**RE: Plan Amendment Case: NPA-2020-0002.02  
Zoning Case #: C14-2021-0058**

Property Address: 1501 E. 6th Street (also known as 1509 East 6th Street and 1510 East 5th Street)

**ECC-NPCT Intention Behind Letter of Support**

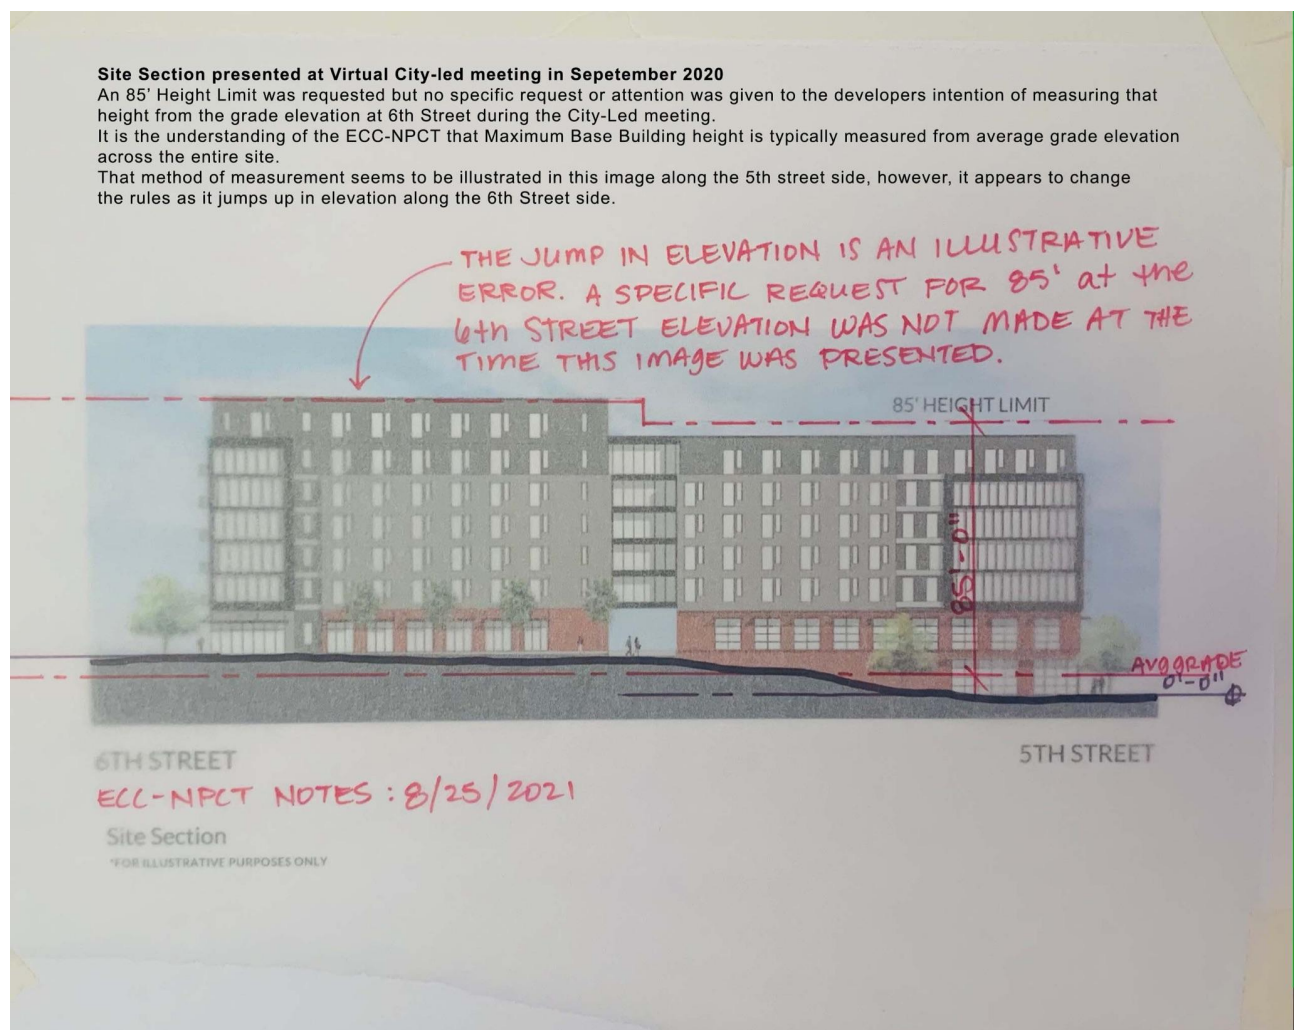
An 85' Height Limit as measured from average grade elevation across the entire site contingent upon the delivery of 10% of the gross SF of affordable housing being committed to family friendly units with a minimum of 2 bedrooms.

Additionally, the ECC-NPCT voted to support a 90' height variance at the south side of the project (Saltillo Plaza side) ONLY, strictly contingent upon the delivery of 20% of the gross square footage of affordable housing being committed to family-friendly units with a minimum of 2 bedrooms.

**Restrictive Covenant Illustration**  
An 85' Height Limit as measured from the finish grade at 6th Street resulting in a 98' height at 5th street.

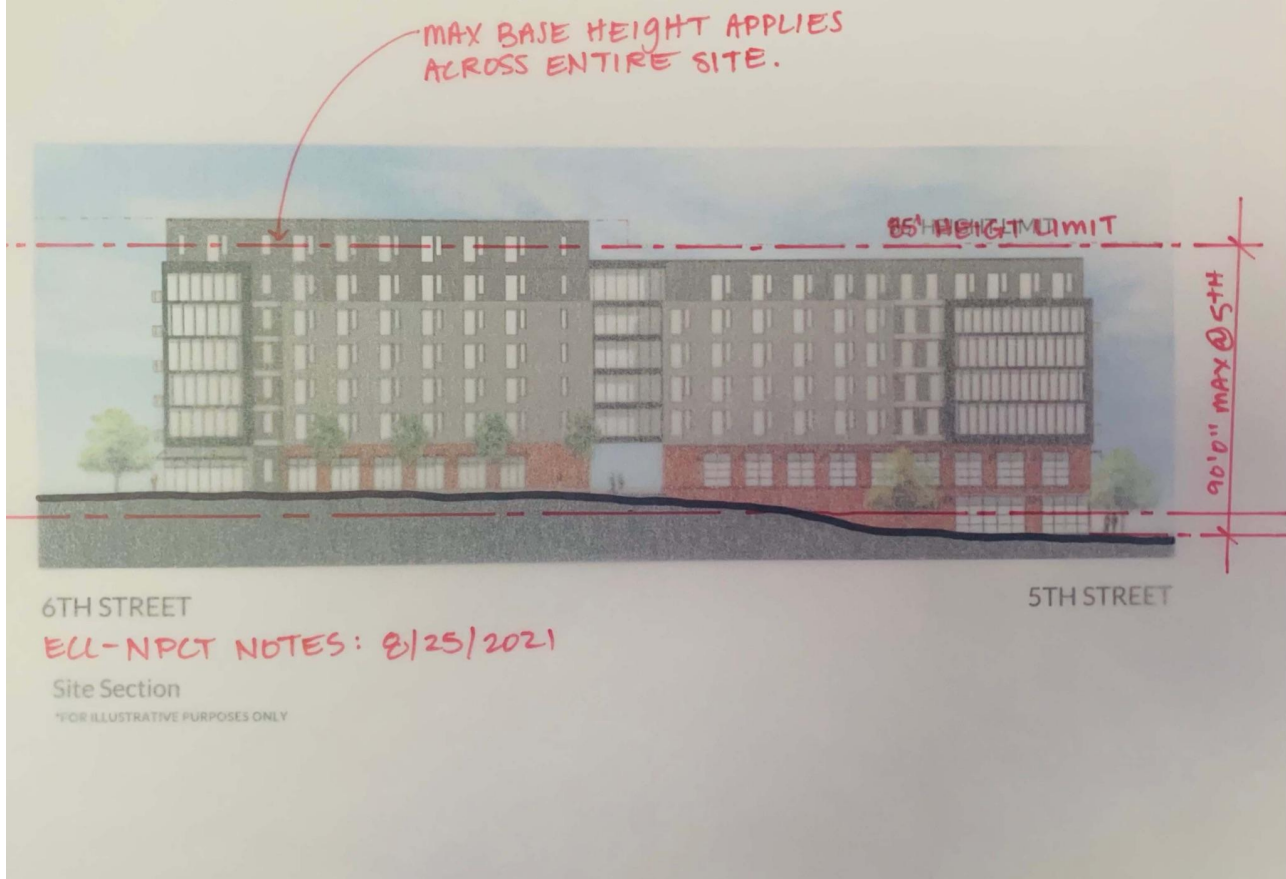
APPLICANTS RESTRICTIVE COVENANT LANGUAGE  
ESTABLISHES A PRECEDENT THAT DOES NOT  
ALIGN WITH THE INTENTION OF WHAT THE  
ECC-NPCT UNDERSTOOD IT WAS AGREEING TO.
